Access Compliance Report

Public Rights-of-Way

(Curb Ramps)

Intersection ID: 20477	Main Street: HIGH_CHASE_LN	Cross Street: MORNING_MIST_LN	Location: NW
ADA ID: EDBD55214481	Ramp Type: PerpDiag	Initial Pass/Fail: Fail	Overall Compliance: No
Severity Score: 13.75			
Codes/Mitigation Info/Possible Solution		Field Measurements/Component Compliance

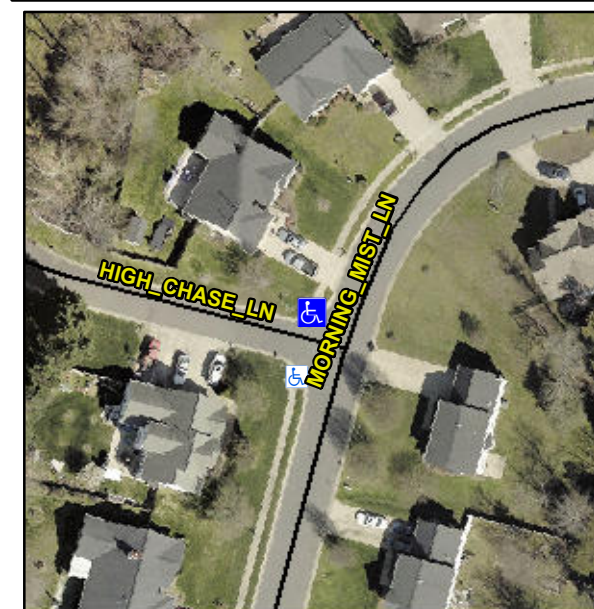
Not Found, R304.2.2, R304.5.3

Compliance	Description	Data	Compliance	Description	Data
N/A	Ramp Length (in)	47.0	No	Ramp Slope (%)	11.6
Yes	Ramp Width (in)	48.0	No	Ramp XSlope (%)	2.5
N/A	Flare Type LT	N/A	N/A	Flare Type RT	N/A
N/A	Flare Slope LT (%)	N/A	N/A	Flare Slope RT (%)	N/A
N/A	Flare Traversable LT?	N/A	N/A	Flare Traversable RT?	N/A
N/A	Landing Length (in)	N/A	N/A	DWS Provided?	N/A
N/A	Landing Width (in)	N/A	N/A	DWS Contrast?	N/A
N/A	Landing Slope (%)	N/A	N/A	DWS Length (in)	N/A
N/A	Landing X Slope (%)	N/A	N/A	DWS Full Width?	N/A
N/A	Landing Curb? (Y/N)	N/A	N/A	DWS Offset (in)	N/A
N/A	Shared Landing?	N/A			
N/A	Gutter Ponding?	N/A	N/A	Gutter Slope (%)	N/A
N/A	Gutter Lip Ht (in)	N/A	N/A	Gutter X Slope (%)	N/A
N/A	Painted X Walk1?	No	N/A	Painted X Walk2?	No
	X Walk 1 Direction	To SW		X Walk 2 Direction	To SE
N/A	X Walk 1 Width (in)	N/A	N/A	X Walk 2 Width (in)	N/A
	X Walk 1 Slope (%)	0.5		X Walk 2 Slope (%)	5.6
	X Walk 1 X Slope (%)	2.4		X Walk 2 X Slope (%)	1.1

N/A	Ramp inside XWalk1?	N/A	N/A	Ramp inside XWalk2?	N/A
	Road Slope (%)	2.8	N/A	Clear Space?	N/A
	Road X Slope (%)	3.6	N/A	Clear Space to XWalk (in)	N/A
N/A	Any Obstructions?	N/A	N/A	Storm Grate/Utility Hazard?	N/A
	Obstruction Type			Storm Grate/Utility Type	
		N/A			N/A
			Yes	Surface Condition? (G/P)	Good

Remove & Replace Curb Ramp With Two New Directional Ramps or Equivalent.
